Corpus Christi Refineries

May 16, 2013

Re: Flint Hills Resources Corpus Christi, LLC - West Refinery
PSD Greenhouse Gas Permit Application
Domestic Crude Project
Response to Information Request
Corpus Christi, Nueces County

RESPONSES TO INFORMATION REQUEST

NHT/CCR Fugitives
EPN: F-39
FIN: 39

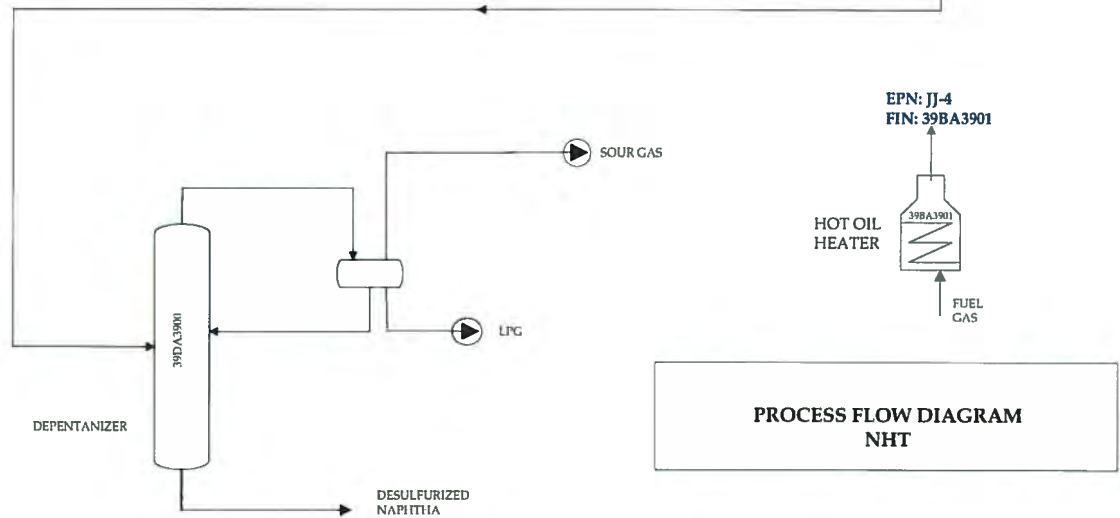
- B. Page 19 of the permit application contains the process description for the Continuous Catalytic Regeneration/Naphtha Hydrotreater (CCR/NHT) Units. The process flow diagrams for these units are found on pages 94 and 95. It is not clear how the catalyst used in the process is regenerated from the description given and the process flow diagram. Please provide supplemental process data on the how "spent" catalyst is regenerated to "fresh" catalyst. The process diagram only shows catalyst feed into the CCR Unit. Is the catalyst regeneration process a potential GHG emitting source?**

A process description for the catalyst regeneration process is provided below. The CCR/TOL FRAC process flow diagram has also been revised to show the vent stream from the catalyst regeneration process (EPN JJ-5). There are no physical changes or changes in method of operation proposed to the catalyst regeneration process, and the regeneration process will not experience any increase in actual emissions as a result of the project. Therefore, GHG emissions from the catalyst regeneration vent are not pertinent to this application.

Catalyst is used to promote the reaction within the Continuous Catalytic Regeneration (CCR) Unit. The catalyst is continuously regenerated and circulated through the reactor section. Spent catalyst is continuously withdrawn from the fourth reactor bed and flows to the catalyst regeneration tower (shown as a box on the process flow diagram with the label "CCR"). The spent catalyst is continuously injected with perchloro-ethylene which promotes the reaction. Catalyst is regenerated in four steps: burning the coke, oxidizing/dispersing the metals and adjusting the chloride balance, drying excess moisture, and reducing oxygen from the metals. The regenerated catalyst is then returned to the first reactor bed. A vent gas scrubber treats the vent gas from regeneration and drying zone excess air in accordance with the Refinery MACT II, 40 CFR 63, Subpart UUU and vents it to atmosphere (EPN JJ-5).

**PROCESS FLOW DIAGRAM
WEST CRUDE**

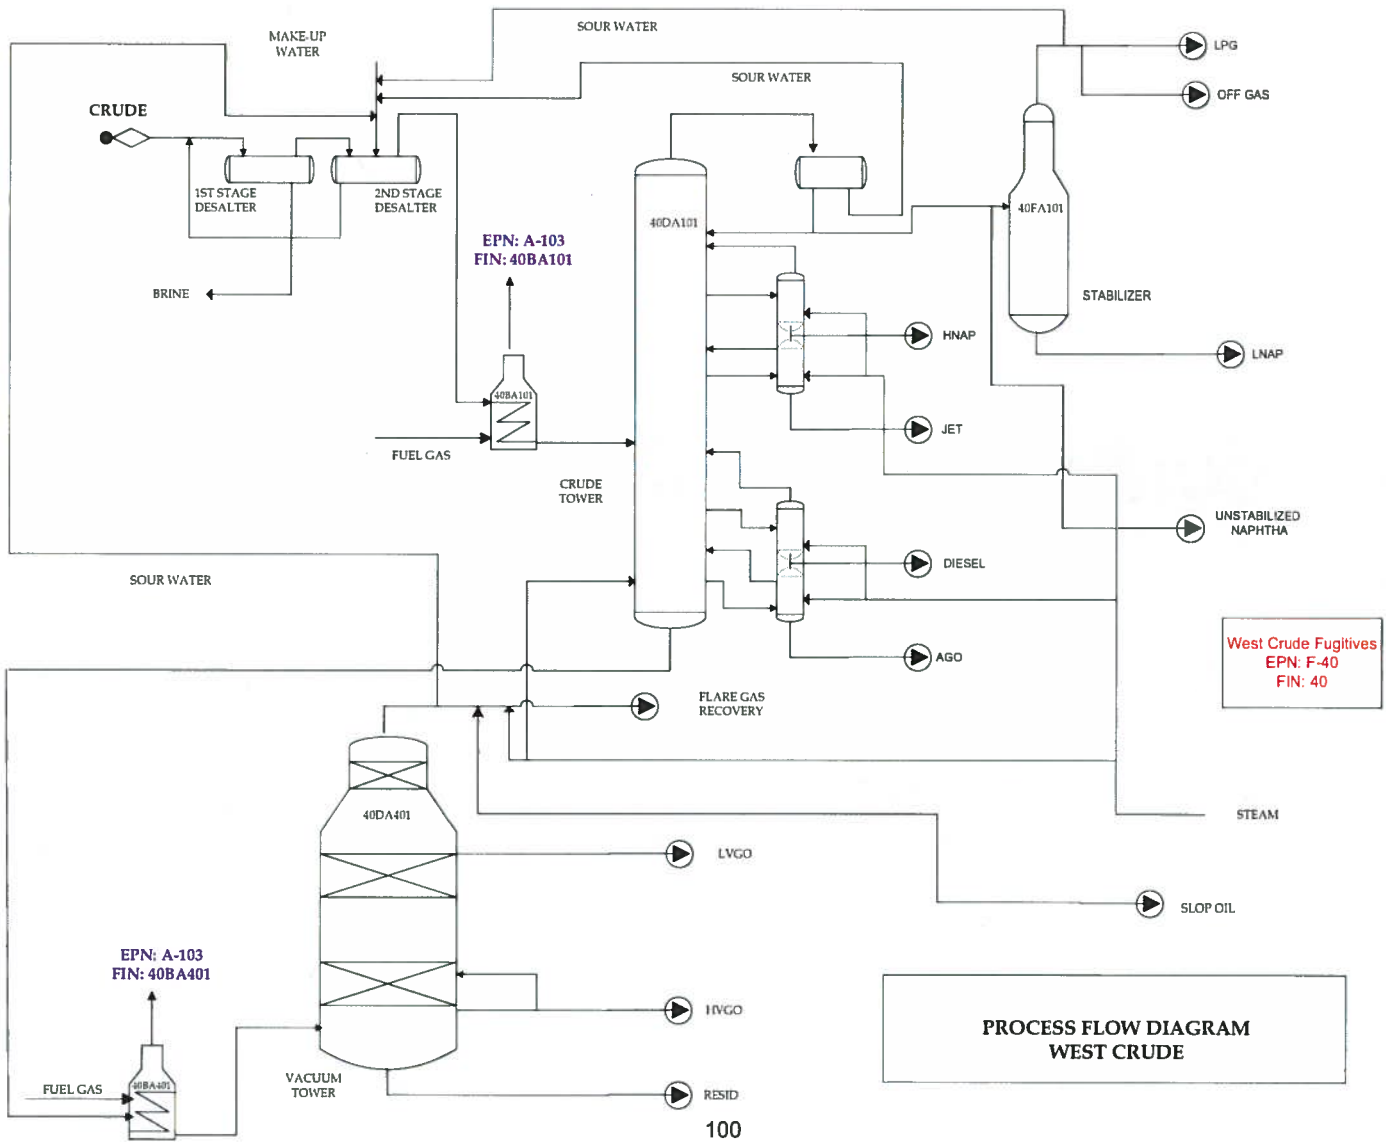
The Crude Charge Heater and Crude Vacuum Heater are two separate emission units that vent through a common stack. Therefore, the two heaters do have the same emission point designation of EPN A-103. There are no physical changes or changes in method of operation proposed to these emission units, and they will not experience any increases in actual emissions as a result of the project. These emission units have been color coded purple to indicate they are not affected by the project. A revised process flow diagram for the West Crude Unit is provided in Attachment B.

WHD ENVIRONMENTAL				
FLINT HILLS RESOURCES CORPUS CHRISTI, LLC				
BOILERS PROCESS W. REFINERY CC, TX.				
DWW	7/9/08	5/2/13	BOILERS	3
CLIENTS\FLINTHILL WEST\KRW\B40\W\PCNT\TABLET\ENG\ APPL PFD

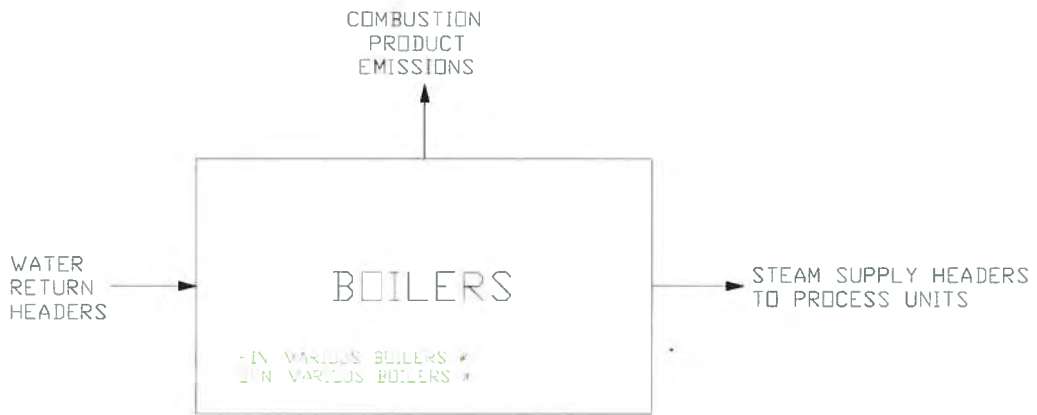
- D. **On page 34 of the permit application, the process description for the Utilities Area states that the West Refinery consists of six boilers. There are no proposed physical changes or changes in method of operation to any of the boilers. However, as a result of the project, there will be an increase in steam demand so the boilers will experience an increase in actual emissions as a result of increased utilization. Because the boilers are affected (existing non-modified) emission units, these actual emissions are included in the PSD applicability assessment. The total emission increases from the six boilers are shown on page 9, line number 3 of Table 2F under one emission point identification number. Also, the process flow diagram on page 101 depicts these six boilers as one emission unit with one emission point identification number. Please provide supplemental information that verifies that these boilers vent to a common stack.**

There are seven boilers potentially affected by the project. The six boilers in the utilities area and the Mid Plant Boiler. Any of these boilers could potentially see an increase in utilization as a result of the project, but the total incremental increase from all of the boilers will not be more than 96 MMBtu/hr as shown in the application. Therefore, the seven boilers have been grouped together into an emission source called "Various Boilers." EPA's question appears to concern pinpointing the location of the emissions from each stack. However, the location of each stack onsite does not affect this analysis. Each of the boilers has its own vent stack. The process flow diagram provided in the application is a general process flow diagram for a boiler rather than a process flow diagram for each individual boiler. A revised process flow diagram is provided in Attachment B, which explains that there are seven boilers potentially affected by the project that have been grouped together into an emissions source called "Various Boilers."

* There are seven boilers potentially affected by the project. The six boilers in the utilities area and the Mid Plant Boiler. Any of these boilers could potentially see an increase in utilization as a result of the project. Therefore, the seven boilers have been grouped together into an emission source called Various Boilers. Each of the boilers has their own vent stack.
